Construction of a new residential care home building comprising 50 no. bedrooms with associated works at Cefn Lodge Nursing Home, 16 Cefn Parc, Skewen, Neath Port Talbot SA10 6YR
Planning Application Reference: P2025/0844

In the interest of clarity, we would like to provide our response to the concerns raised to provide additional information on the scheme and to address the comments raised by the consultees:

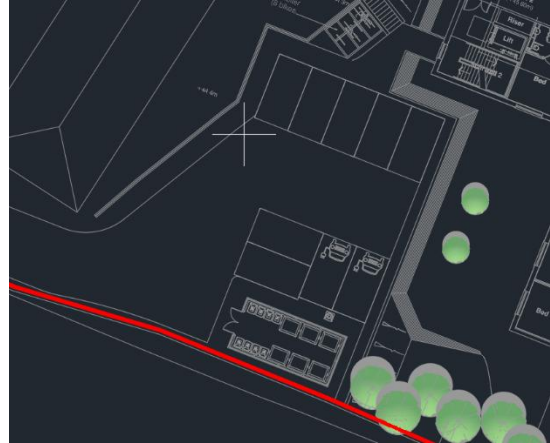
The CAD files for the two EV spaces within the staff car park has not been provided. It was also raised that	The two staff electric vehicle parking bays are physically shown on the planning-stage layout

there are concerns that if inconsiderate parking was to occur, the spaces would not be able to be accessed, please review and include measures to reduce inconsiderate parking

previously issued to the Council, located within the private staff hardstanding/car park area. The CAD file which we sent on request clearly showed these spaces – for reference below is the extract of the CAD file with the spaces shown.

In terms of inconsiderate use of the EV bays, this is a private, staff-only hardstanding, not a public car park. Misuse of EV bays in managed private facilities is inherently low, and any obstruction can be addressed immediately through CCTV and routine physical monitoring.
